CITY OF NORTH PORT

CONTRACT/AGREEMENT AMENDMENT FORM

Amendment No.: 2

Project Name: MCWTP Structural Rehabilitation Phase 1 – Flocculation Tank No.1 Repairs

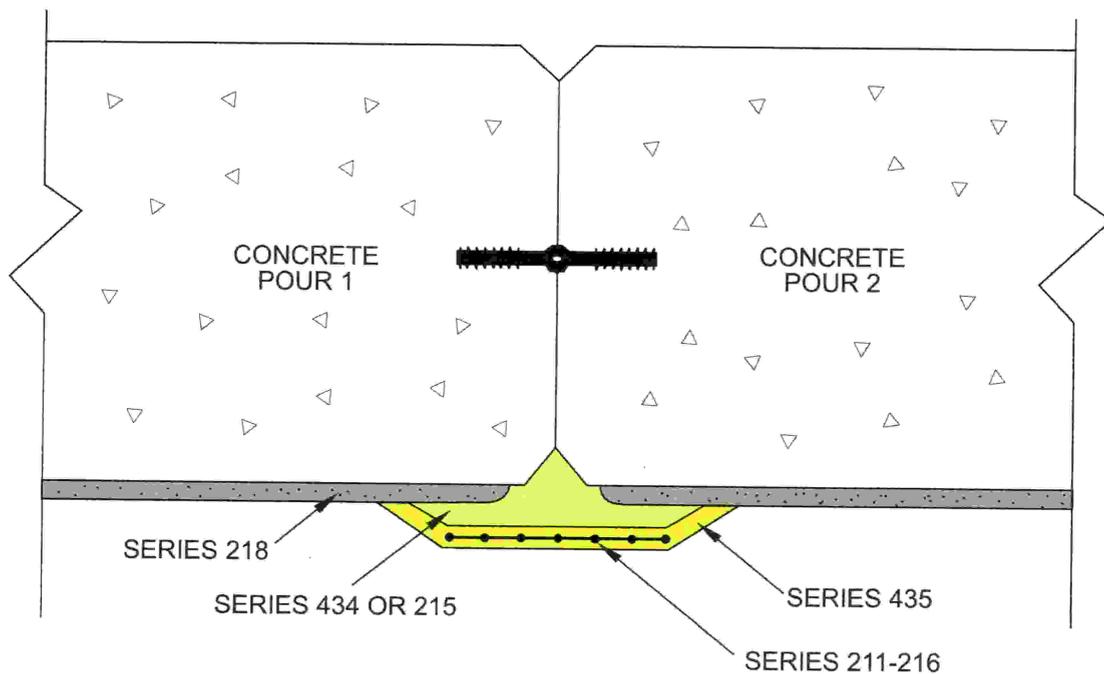
Detail A, on Plan Sheet S-1 of the plans, shows that two pours are to be done, for the foundation slab, with a water stop being placed between the pour joint. ZEP Construction's installation of the slab pour on the construction joint between the two slabs was done per the plans and specs.

After over 28 days, a separation of the floor slab was formed due to the shrinkage of the concrete.

In most concrete slab installations that have two pours, this is a common occurrence. Since ZEP construction performed the operation per plans and specifications, we find that it is not in any way a fault of ZEP Construction's pour of the concrete.

Our subcontractor RPS will repair the crack, per the attached email and sketch. The bid already has repair items and we are requesting that the 35 LF of Crack repairs that were agreed to on RFI #6 be restored to the original bid quantity of 50 LF. The restored 15 LF would cover the cost for the repair.

We will provide a recommendation to repair the crack along the construction joint in the new base slab (see attached pictures) in a day or two.

The corrective action we propose is as below. Chad H please comment if any edits are required per your experience: Provide a fiberglass mat detail similar to the attached PermaShield Construction Detail PLS-11 to offer crack bridging and dissipating minor movement. Then apply the specified system over the top.

- Tnemec Series 215 used as both the bed coat and saturant coat (this is NSF 61 compliant)
- Fiberglass mat Tnemec's Series 211-216. This is acceptable as long as it will wet through and you do not use less than a 4" wide strip.
